# ARM720T r4pN Errata List

Document number: ARM720T-PRDC-003802 4.0  
Date of Issue: 20 March 2009

This document describes the known errata in the ARM720T r4p3 design.

Fig 1: EXTCPA/EXTCPB as driven in the AVS testbench

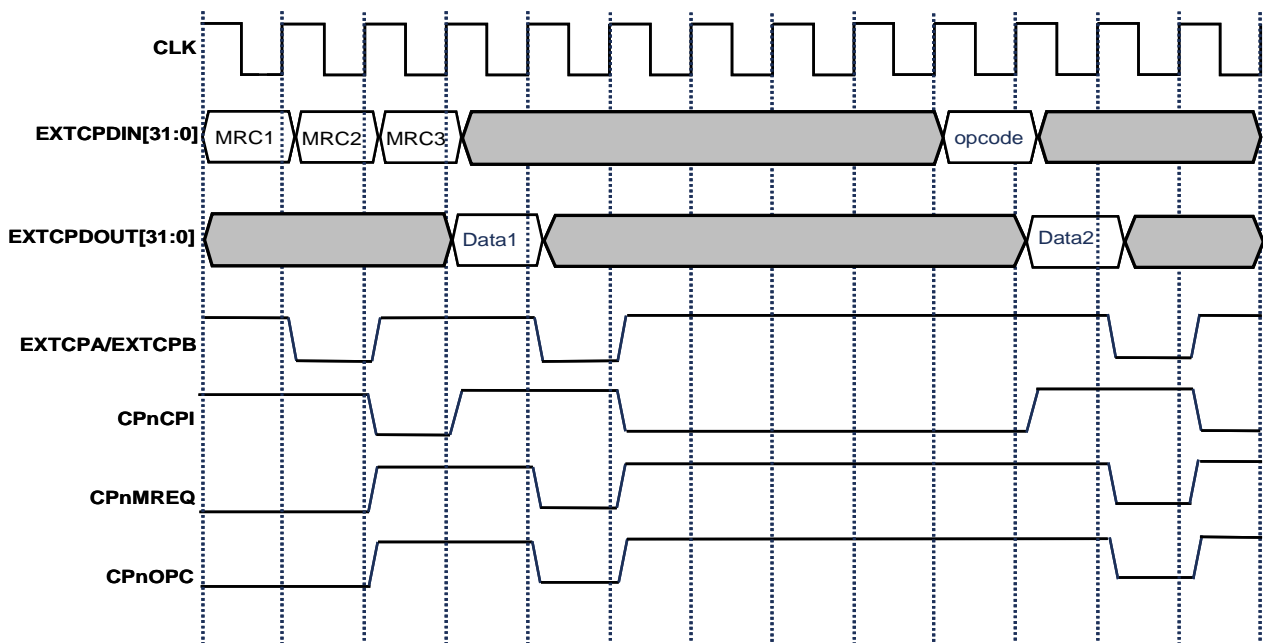
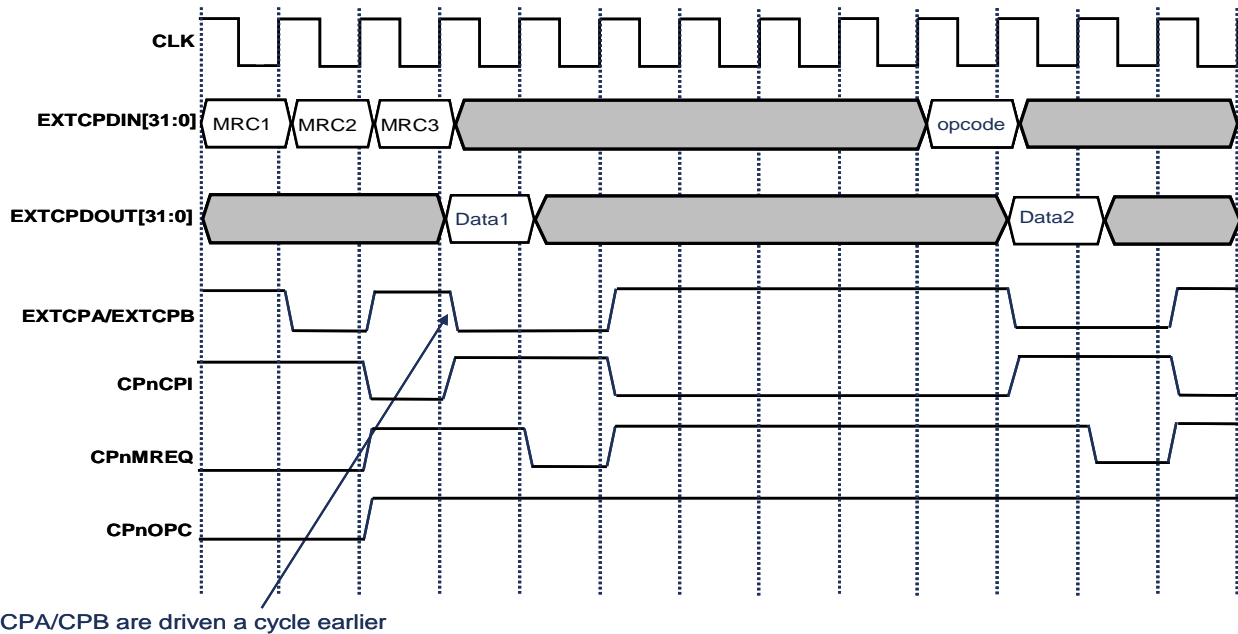
If two or more MRC instructions are fetched sequentially, the second and any subsequent MRC instructions may not be correctly executed by the core.

The bug is only encountered if the value of <opcode\_1> is set to 3'bx1x and only if EXTCPA/EXTCPB are being driven low by the coprocessor a cycle earlier with respect to CPnOPC/CPnMREQ going low. The bug only affects external coprocessor accesses and not internal CP15 operations.

Figure 1, shows how EXTCPA/EXTCPB are driven in the AVS testbench, causing the bug not to trigger.

Figure 2, shows how the bug is triggered, e.g. when EXTCPA/EXTCPB are driven a cycle earlier by the coprocessor.

- 1: Delay EXTCPA/EXTCPB inputs by a full clock cycle, e.g. so that they are taken low when CPnOPC/CPnMREQ go low.
- 2: Insert a NOP instruction between each MRC instruction that appear in program code, there will be an overhead of an additional instruction for each sequential MRC instruction fetched and executed by the core.
